DEIR FINAL DISCUSSION AND SUMMATION

Alon Perlman, January 30, 2009 (Letter P40)

Source Table 5.11-2: Agricultural Resources Proposed Mitigation Measures”

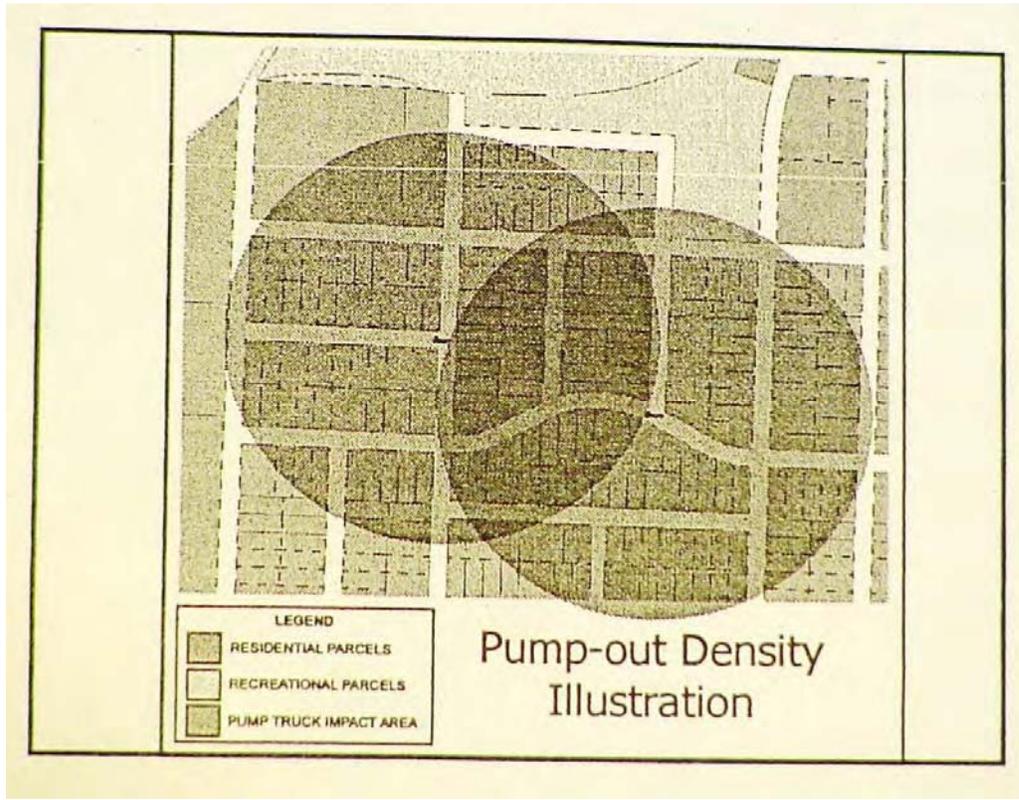
5.11-B1: Provide fencing of areas currently grazed on the Tonini parcel, and a buffer between the boundary of the disposal area and areas currently grazed. The width of the buffer shall be determined in consultation with the San Luis Obispo County Agricultural Commissioner’s office.

Impact Significant and Unavoidable.

This comment concerns fencing and buffer zones around the sprayfield disposal area. The majority of the Tonini site will be used for sprayfields as shown in Appendix Q's Exhibit Q.3-2 in the Preferred Project description. Areas that will not be sprayfields are the wastewater treatment plant facilities, storage ponds, a powerline easement, and protected areas like ESHAs, Sensitive Resource Areas and wetlands. The sprayfields will be fenced to prevent access. As required by the California Coastal Commission, 100-foot buffer zones will be provided from coastal creeks and other protected areas on the site as shown in Exhibit Q.3-2.

Greenhouse Gas Emissions

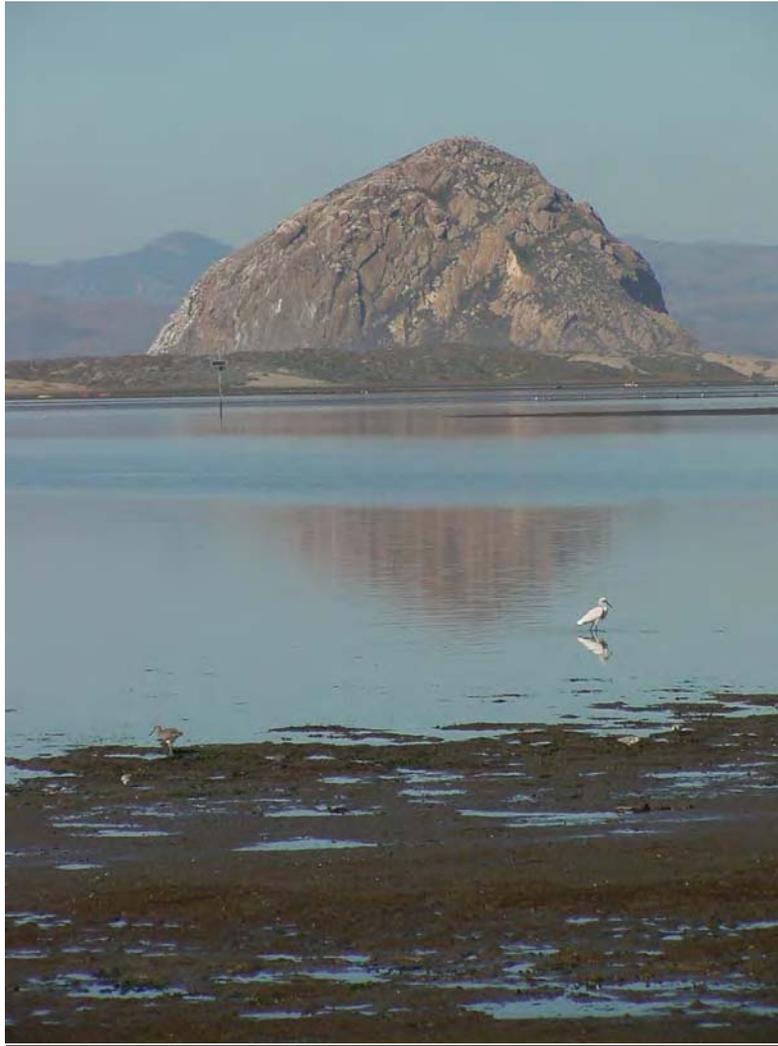
Effectively a wash in the opinion of this reviewer. Due to operating under the structure of "Meeting Thresholds", all projects are considered the same. This makes it harder to review "co-equal analysis" in order to identify or quantify the best project. But that is not the regulatory primary concern. The regulatory body is interested in mitigating and protecting for maximum health and environmental protection.

In order to grow as a grass the plant sequesters carbon dioxide (which is good, trapping a green house gas). After transportation to the landfill, the grass decomposes re releasing some of the carbon dioxide (which is ok) and methane (which can be collected as fuel which is good, or allowed to escape into the atmosphere which is bad) unrecovered methane and other released decomposition gasses can be worse green house gasses. Is potential recombination, release of methane an affect? Is it recognized in the DEIR? Mitigated?

This comment asks if the carbon balance that occurs through the life cycle of grasses grown on Tonini site was considered in the GHG evaluation. Under international greenhouse gas accounting methods developed by the Intergovernmental Panel on Climate Change¹, biogenic carbon is part of the natural carbon balance and it will not add to atmospheric concentrations of carbon dioxide. It is therefore recognized practice to not include this type of GHG emissions in any inventory activity.

Depth to Groundwater Surface Model

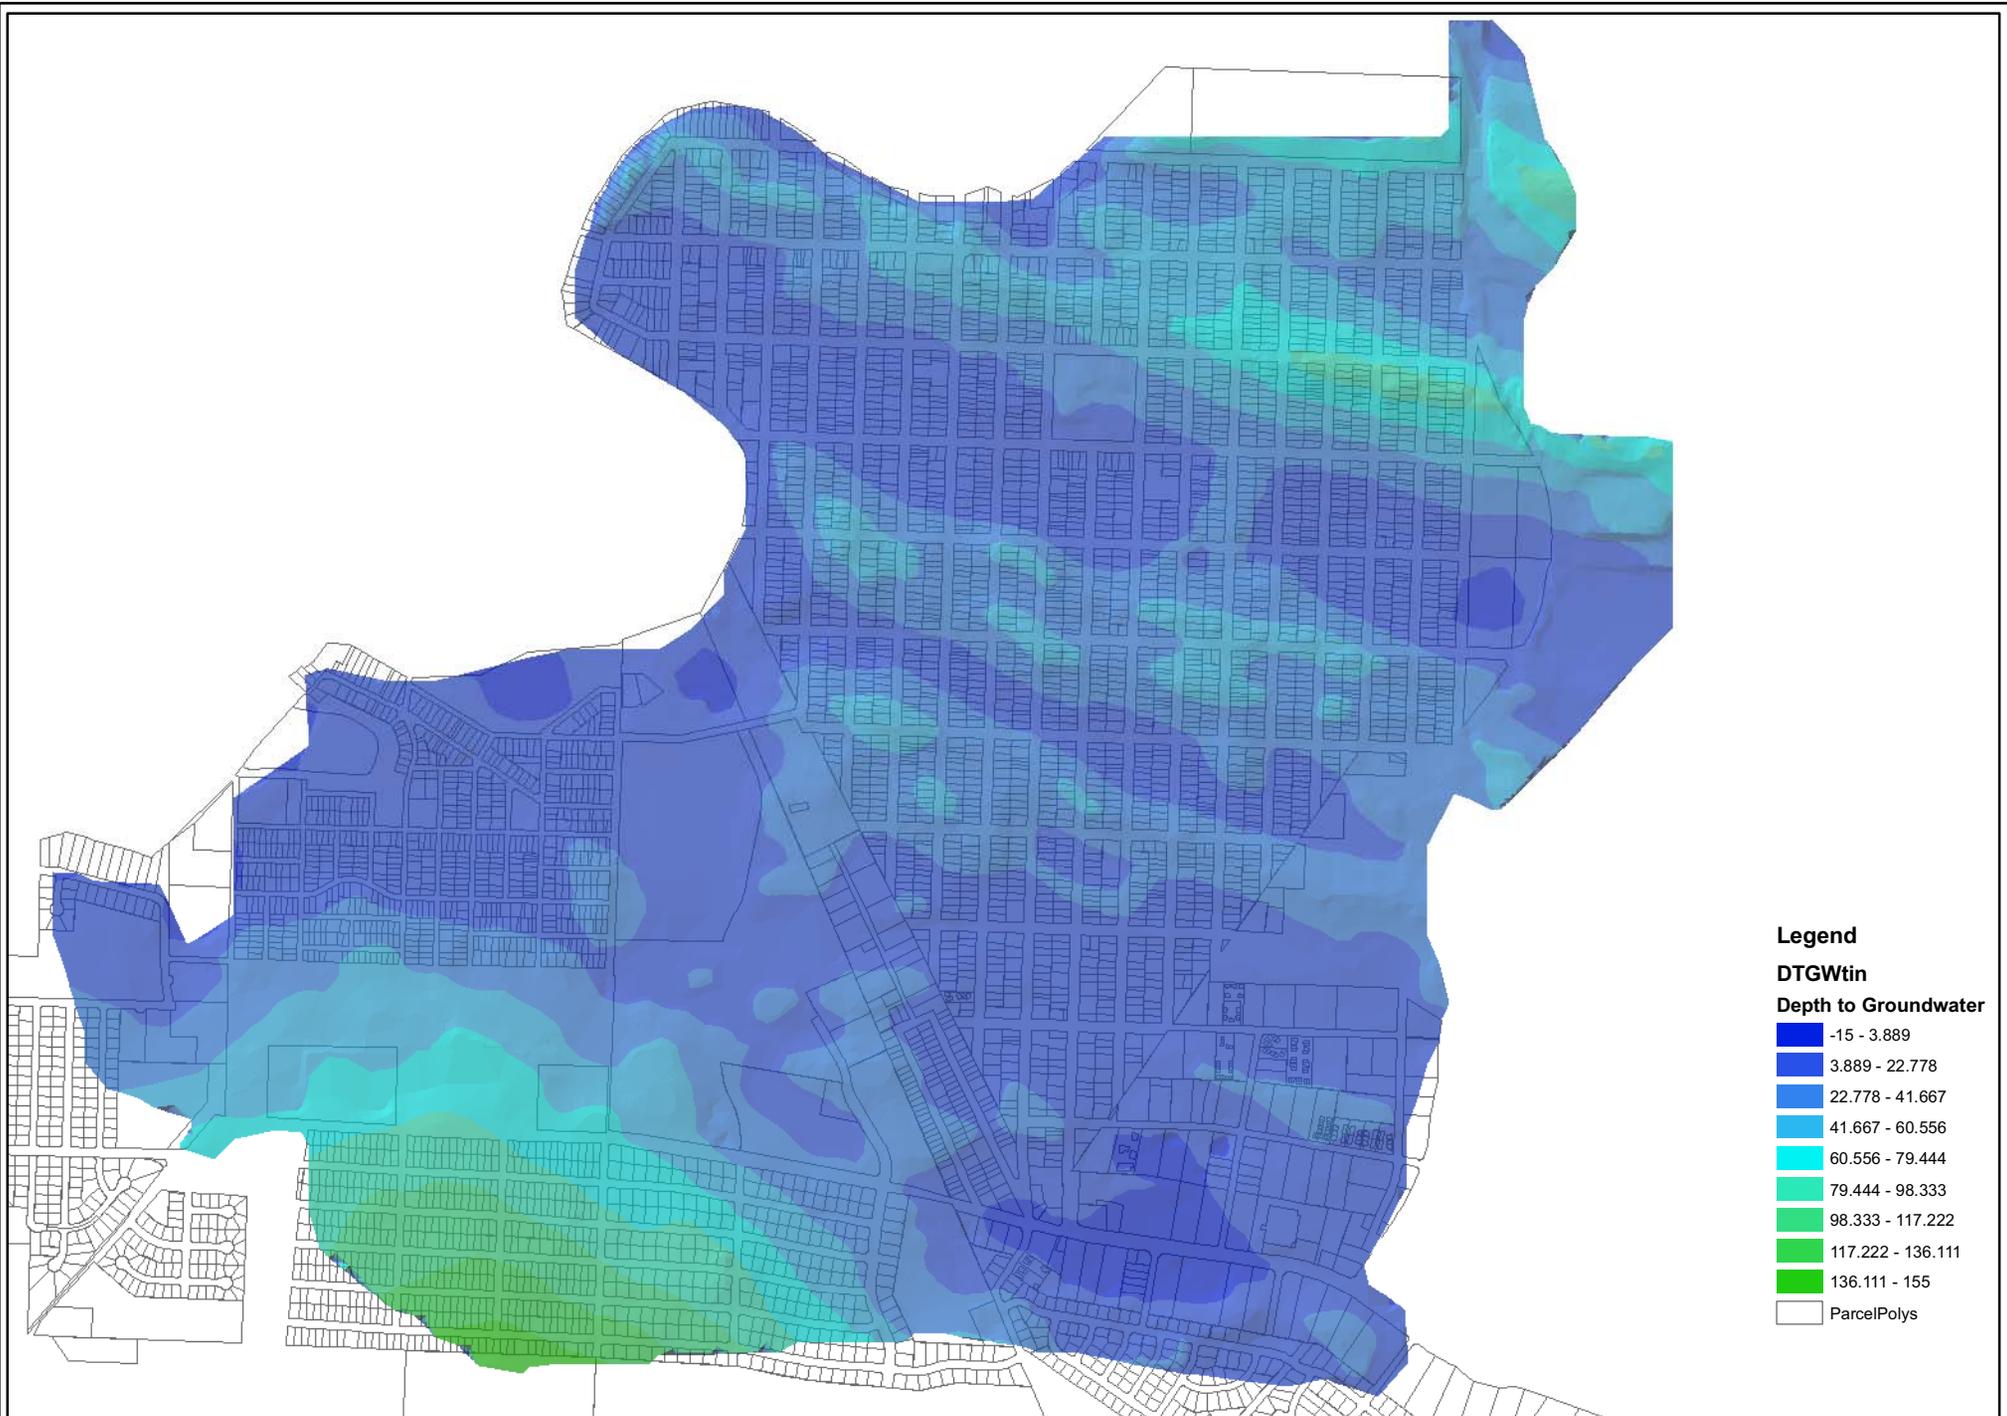
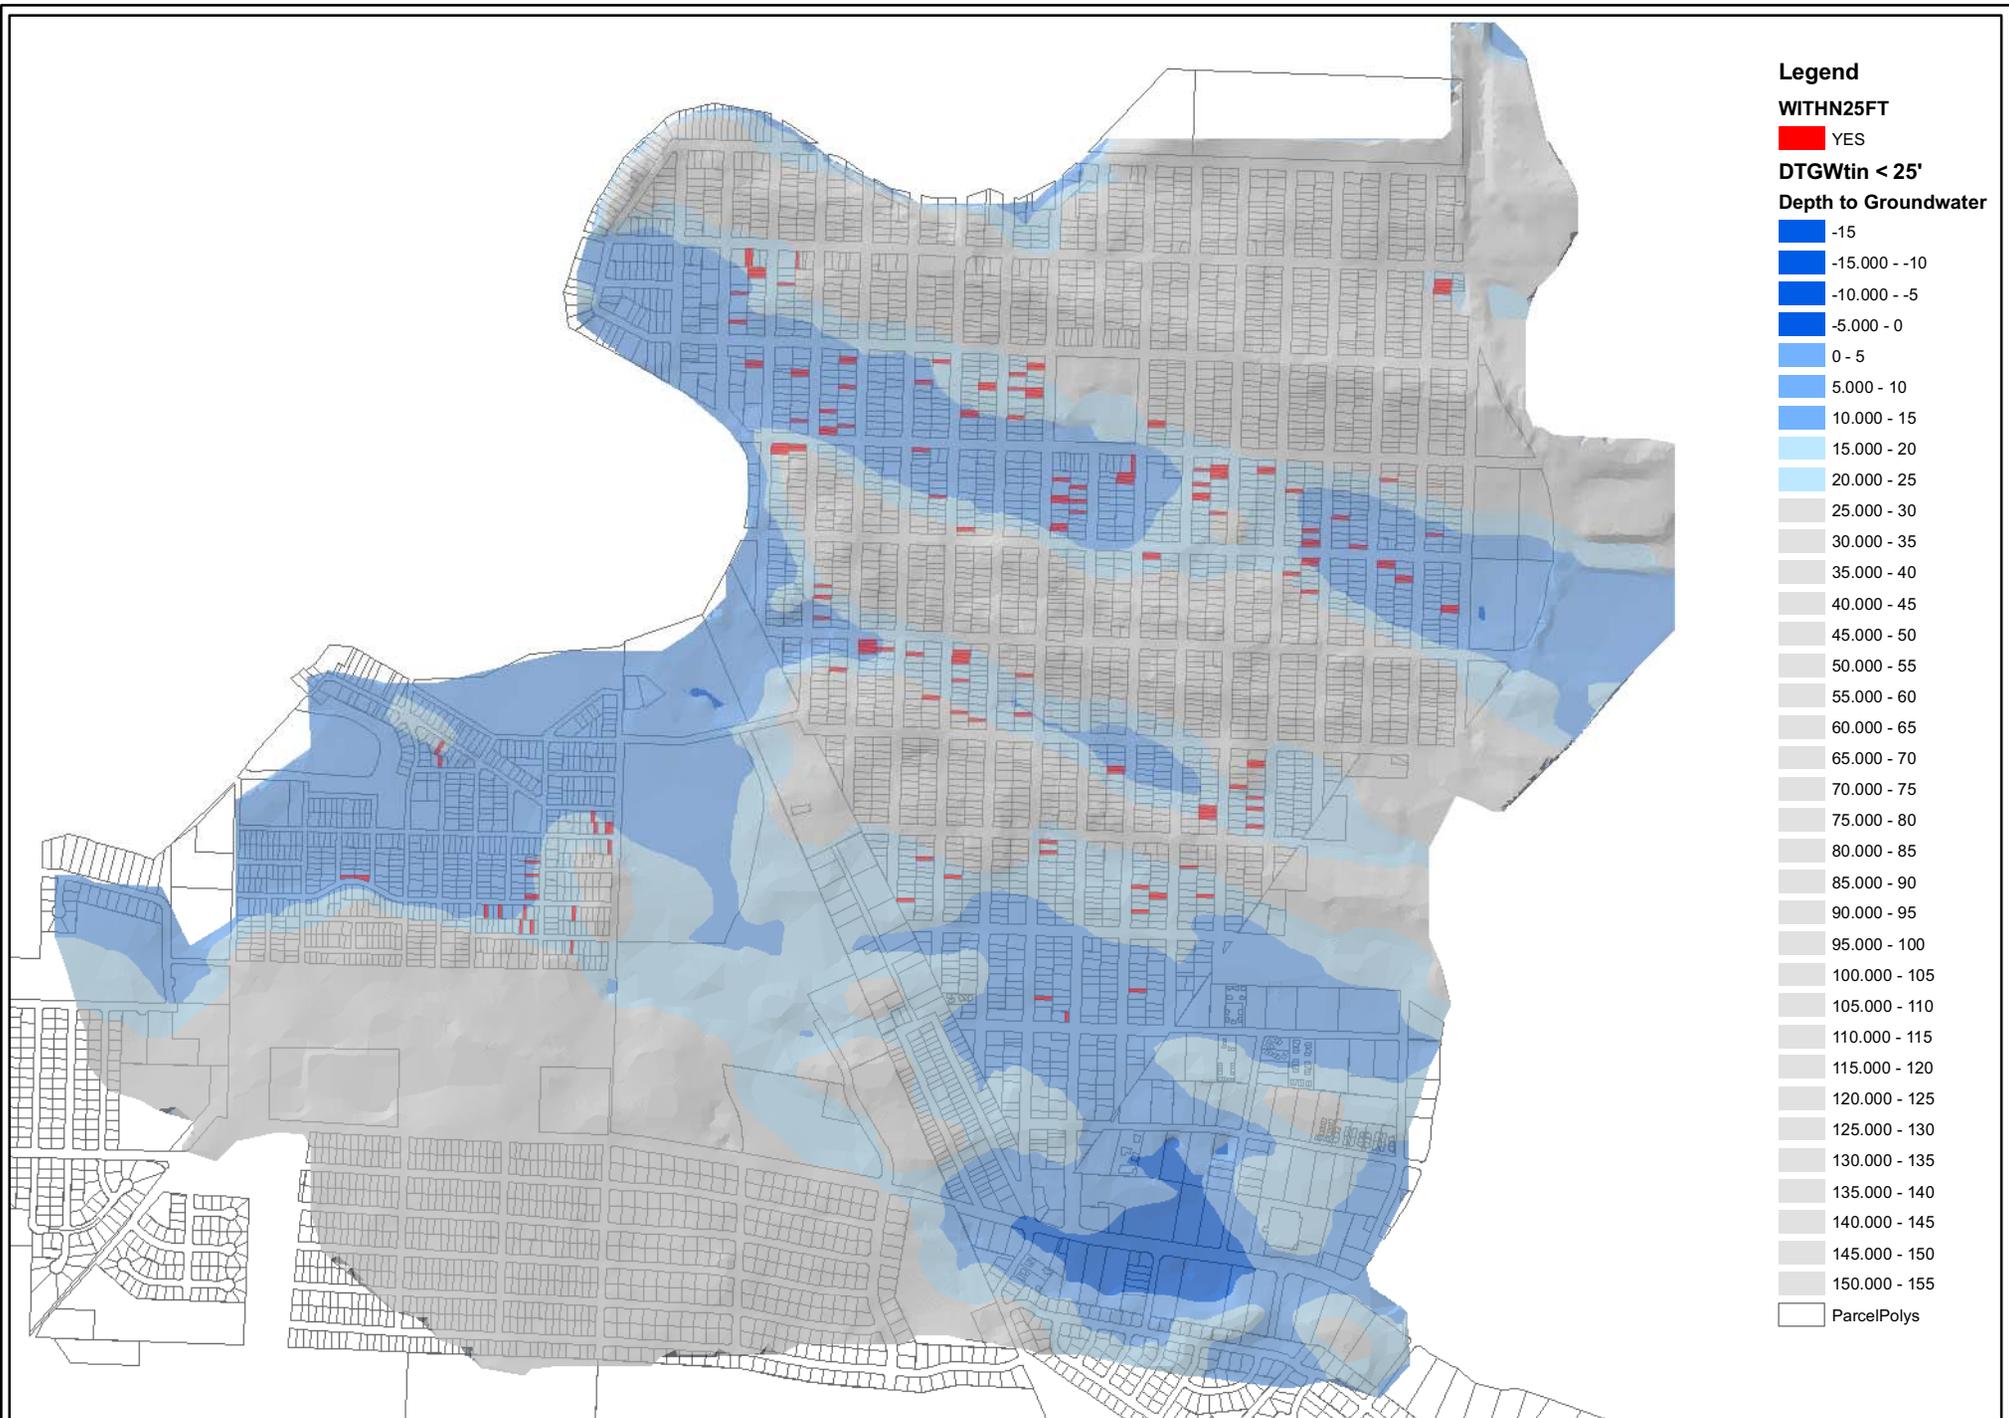
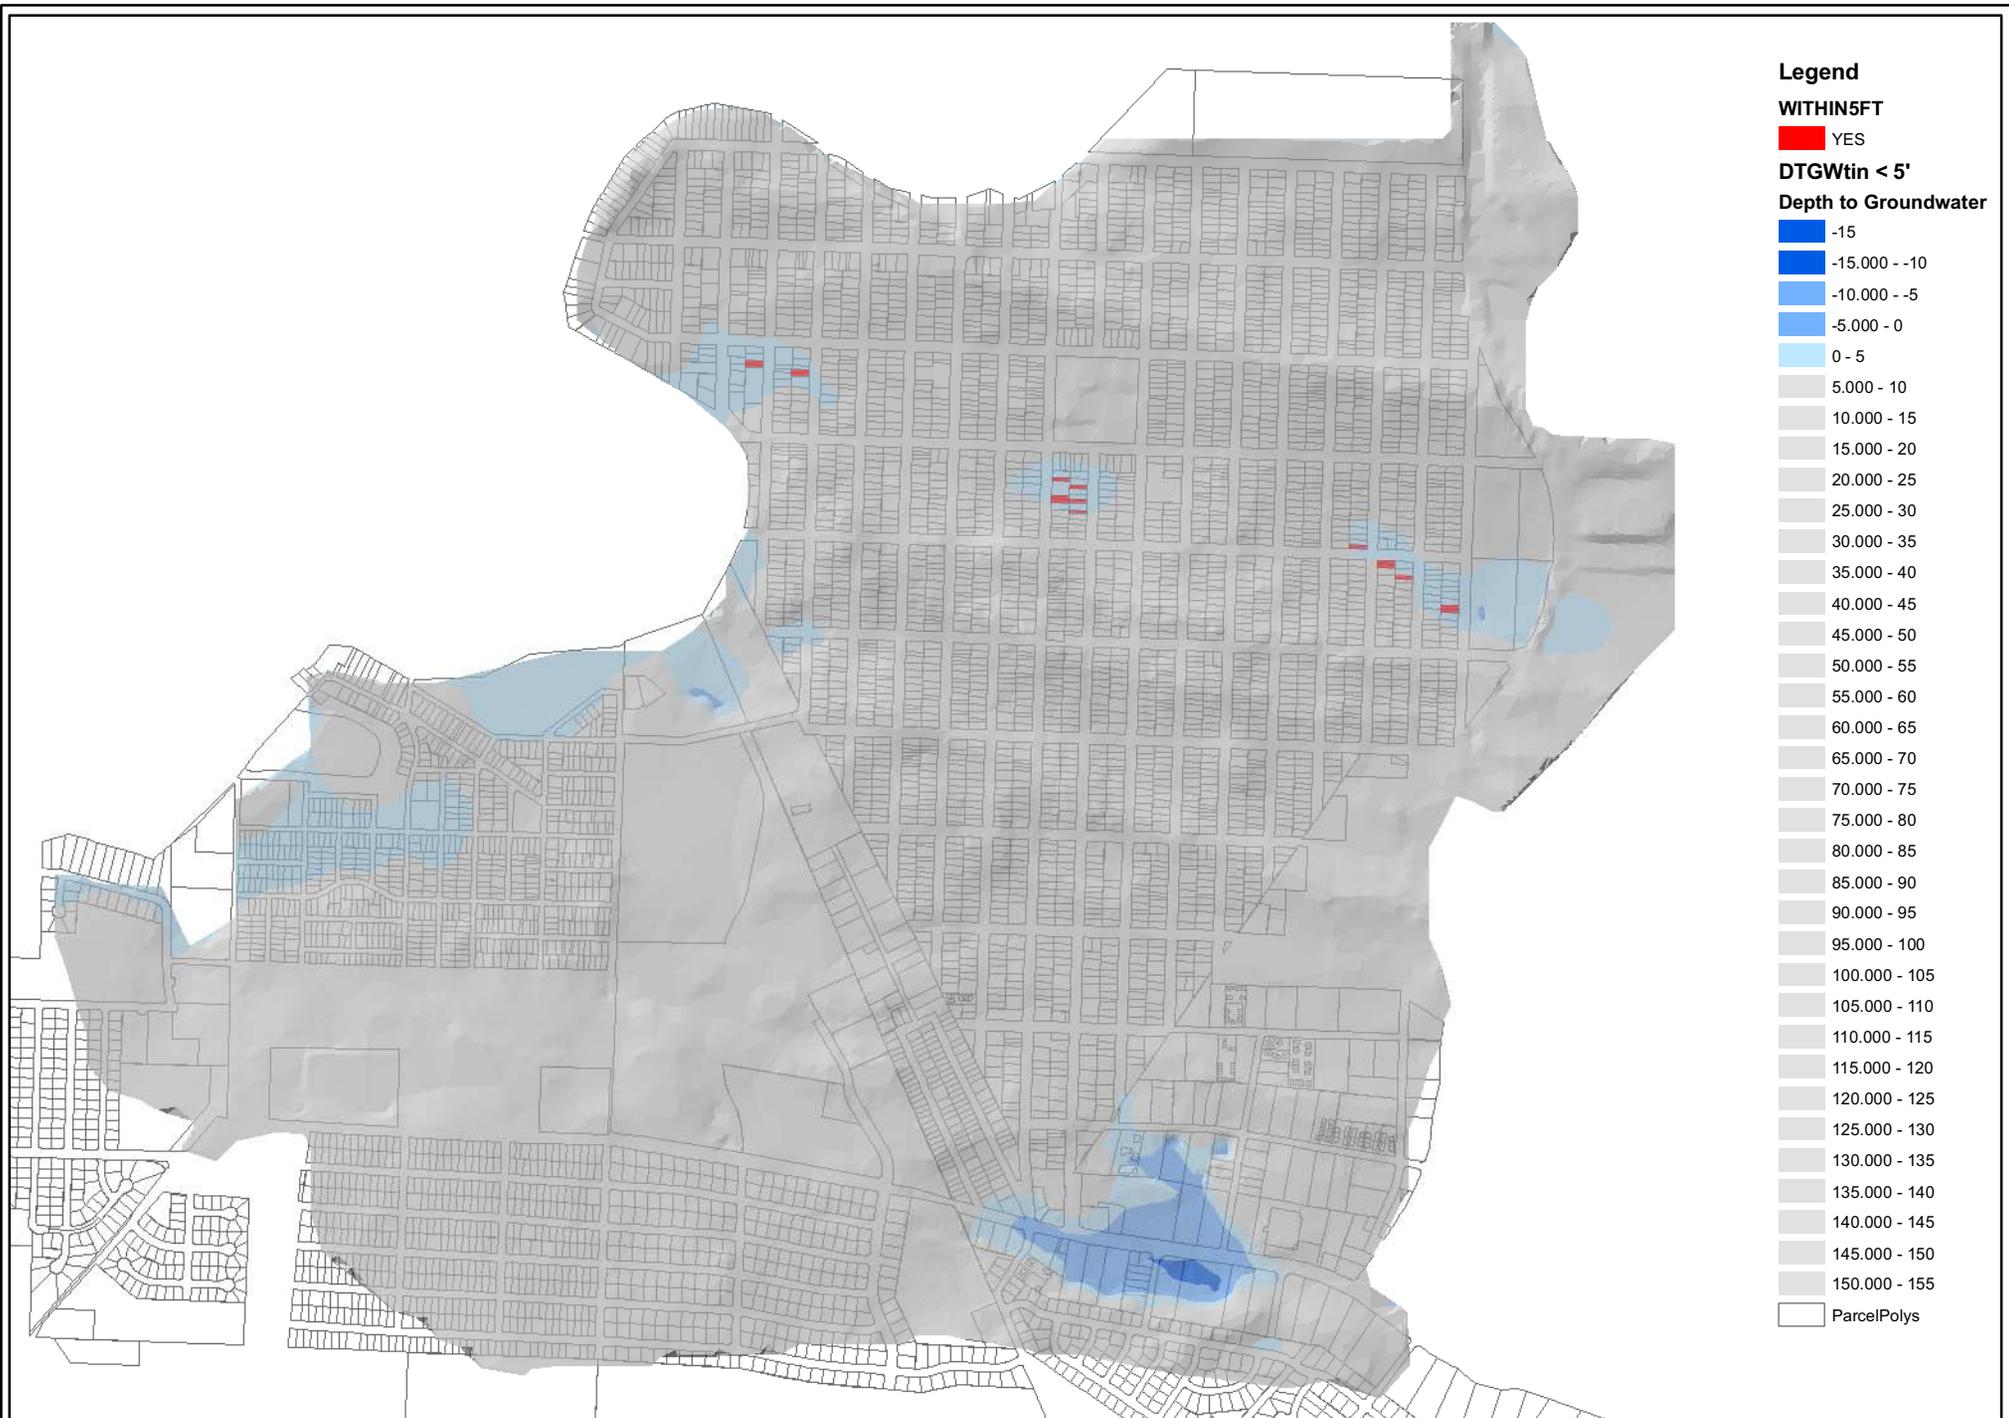
The Fatal Flaw

Though it is appropriate to use questions, this reviewer is not able to avoid stating that (and as presented to the SLO counties supervisors) applying secondary treated wastes (liquid or solid) to agricultural lands or, to replenish a reliable thousands of year old aquifer and a still mostly intact sand filter that created the aquifer, will not work.

The county needs to obtain guidance from it's own EIR Document. This need is hampered, by this disparity between what the EIR is stating (secondary treatment), and what will more than likely happen, after more delays (Tertiary treatment).
